From: Neil Duffield
Sent: 18 December 2020 10:05
To: Kelsey Blain
Cc: 'Jamie Agar'; 'Joseph Kingham'
Subject: RE: Downhill Cottage, Robin Hoods Bay E11726- nymnp re beam 18-12-20

Further to recent emails and my conversation with Jamie the contractor I attach a copy of drawing D11726-04B revised to show the beam location.

| PROJECT: Downhill Cottage Main Rd Robin Hoods Bay YO22 4SF | | |

| DRAWING TITLE: Existing and Proposed First Floor Plan | |

Proposed First Floor Plan

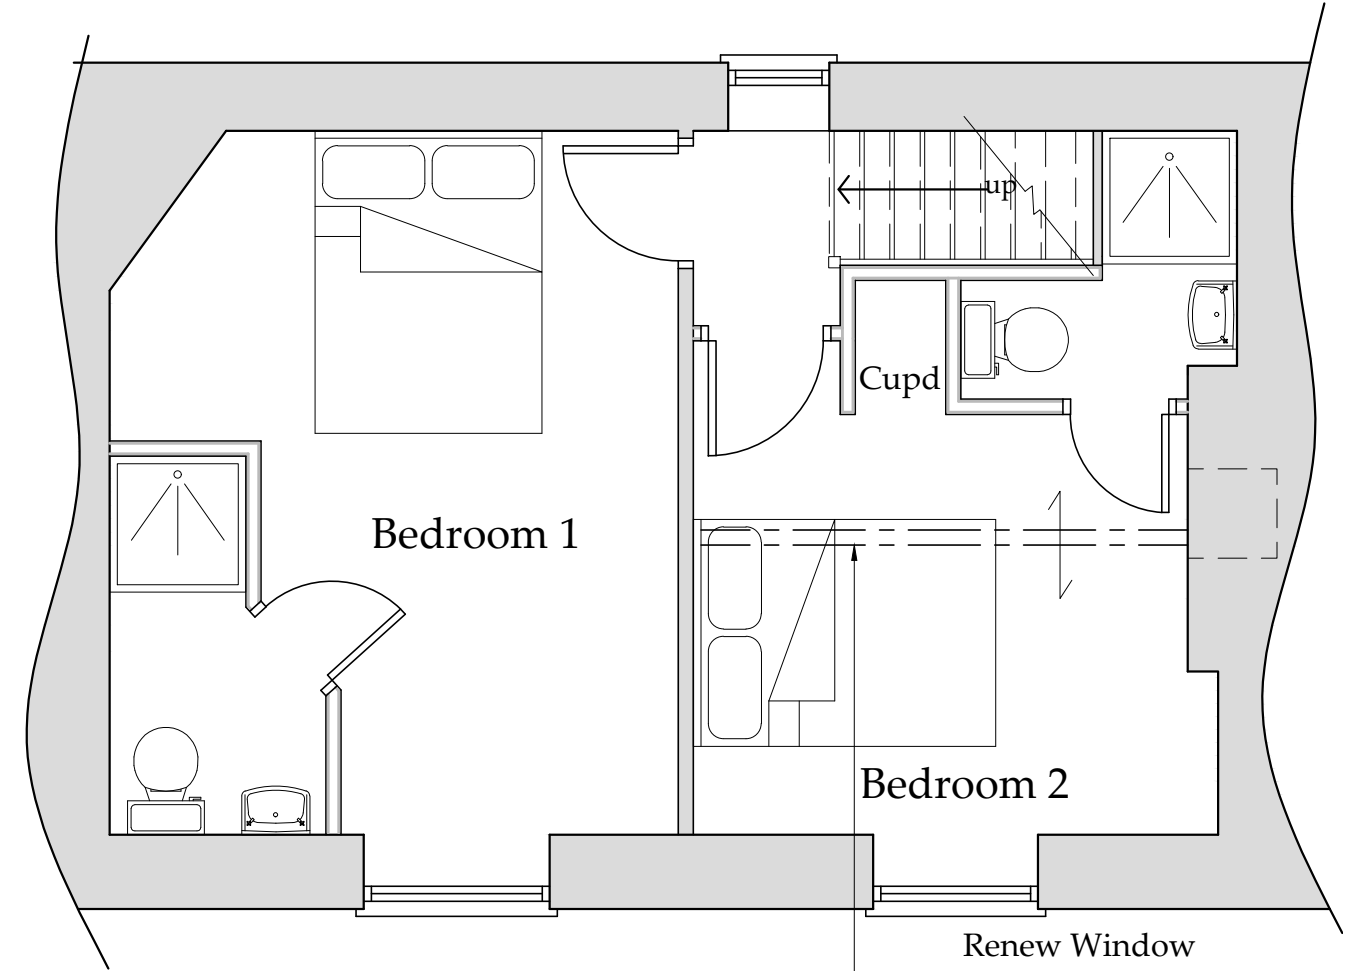
Renew Window
Steel beam to reduce span and 'spring' of floor joists
100x 200 outside dimensions, black painted

| REV | DATE | BY | AMENDMENT | CHKD | APVD |
|-----|----------|-----|---------------------|------|------|
| B | 18/12/20 | NID | Steel beam added | | |
